Hiawatha Corridor LRT Yards and Shops Mitigation Study

Hiawatha Corridor LRT Yards and Shops Mitigation Study

Tie and Ballast

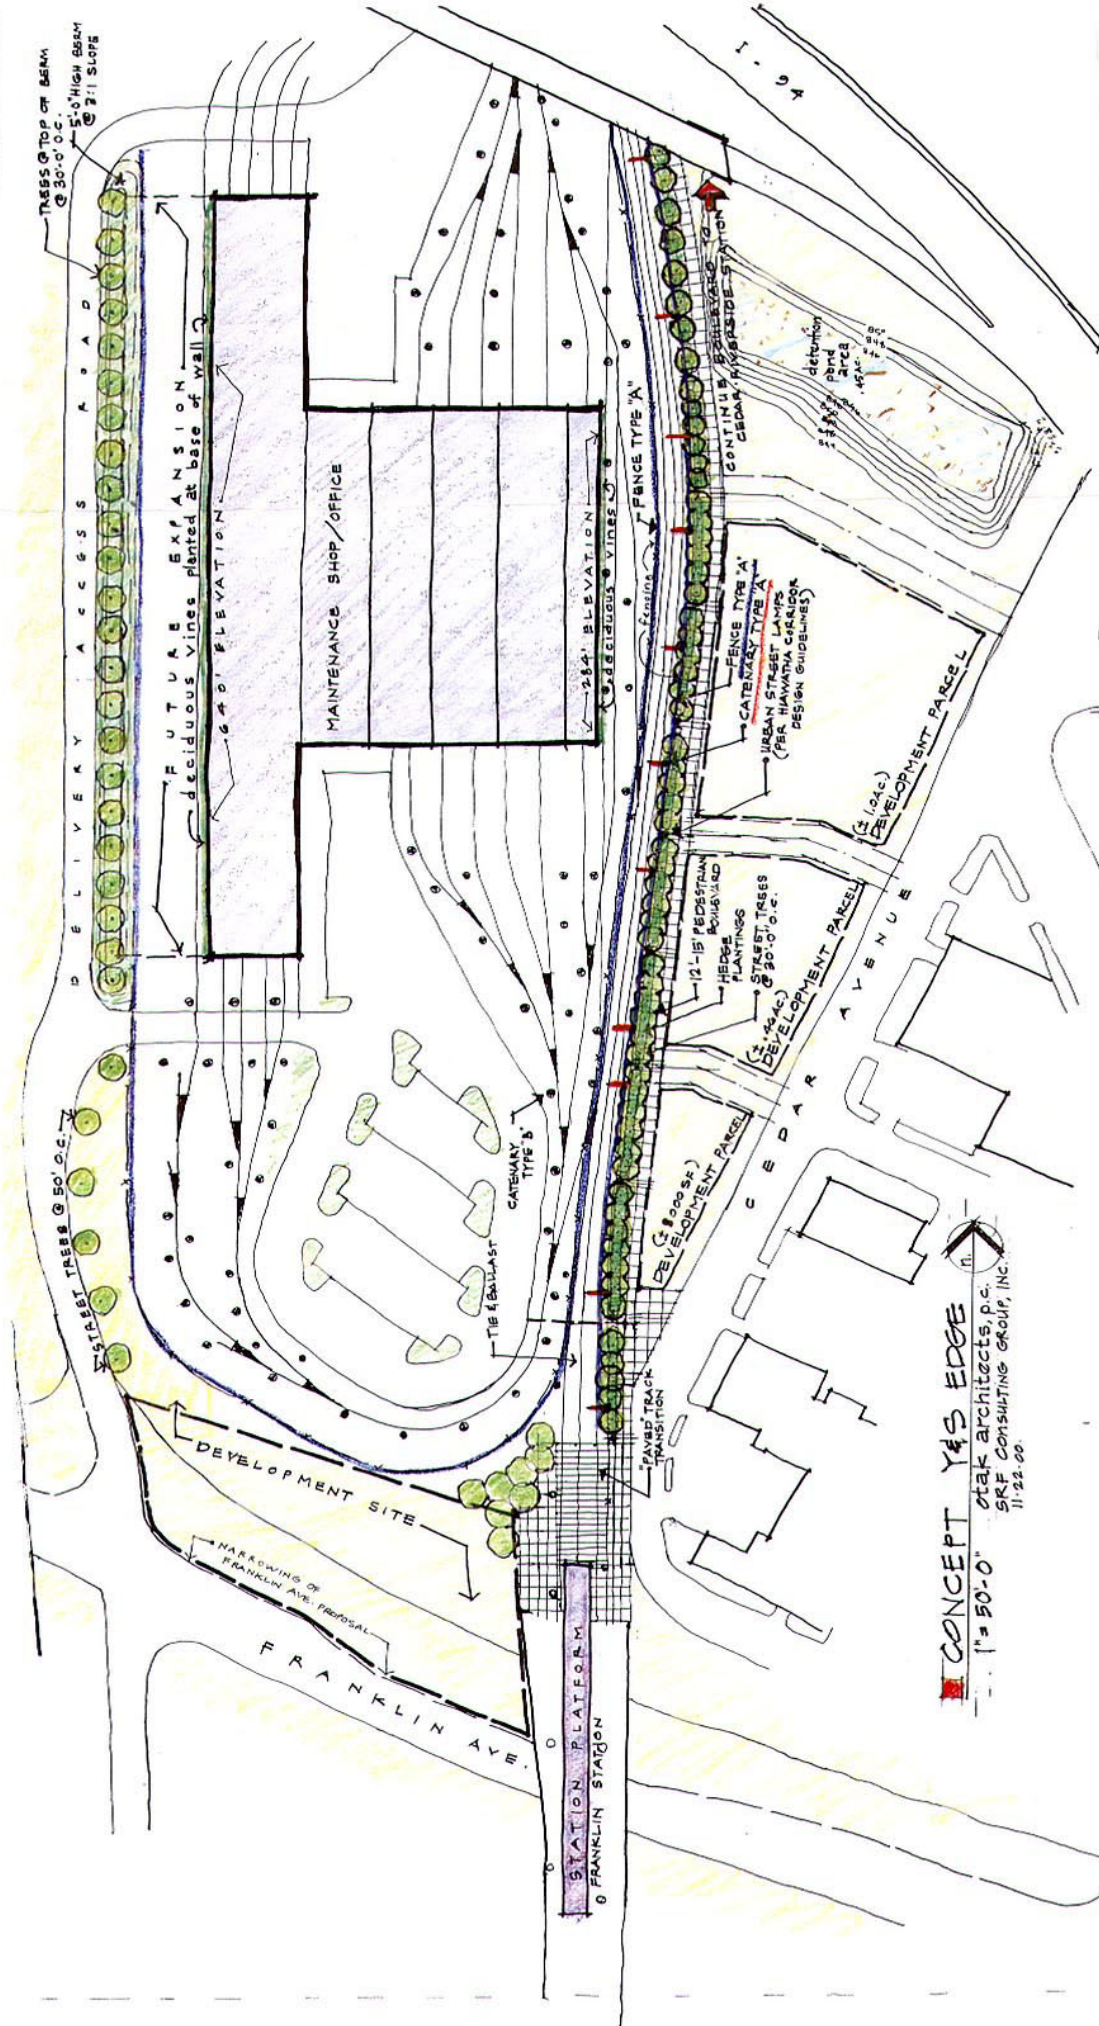
The trackway is specified to be 'open tie and ballast,' which is appropriate in this location. However, we do recommend that an 'extended crossing panel' area be considered at the northern end of the Franklin Station platform for a more 'urban' transition and connection of the two development parcels east and west of the Franklin Station.

Approximate range of \$10.00 to \$12.00 per square foot hard surface area.
